Approval and Promulgation of Implementation Plans; North Dakota;
Regional Haze State Implementation Plan; Federal Implementation Plan for
Interstate Transport of Pollution Affecting Visibility and Regional Haze;
Final Rule

[EPA-R08-OAR-2010-0406; FRL-9648-3]

ACTION: Final rule.

Figure 1. Coal-Fired Boilers Operating Below 0.17 lb/MMBtu

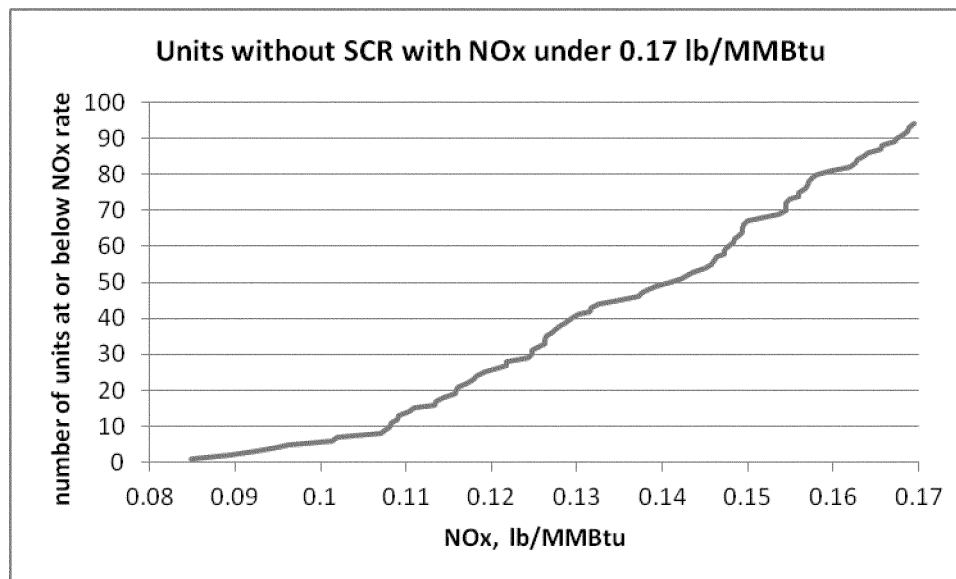
Analysis of emissions data found significant discrepancies in Figures 2.2 and 2.3 of GRE's November 2011 Refined Analysis. A review of EPA Title IV data for 2010 showed 94 coal-fired boilers that do not have SCR achieve annual emissions levels below 0.17 lb/MMBtu, with the median slightly under 0.14 lb/MMBtu (see Figure 1 below). Of these, ten of them are using SNCR in combination with combustion controls to achieve under 0.17 lb/MMBtu. See docket for a list of these facilities. Of these ten, three are supercritical tangentially-fired boilers that use lignite coal with emissions below 0.14 lb/MMBtu. These include Big Brown 1 and Monticello 1 and 2, as discussed earlier in our responses. In addition, the NEEDS Database v.4.10 for the Final Transport Rule in the CSAPR docket includes two tangentially-fired coal/steam units from North Carolina with LNC3 and SNCR that had emission rates of 0.159 lb/MMBtu and 0.164 lb/MMBtu.

As we explain elsewhere, we have decided to revise the BART limit from 0.12 lb/MMBtu to 0.13 lb/MMBtu on a 30-day rolling average.
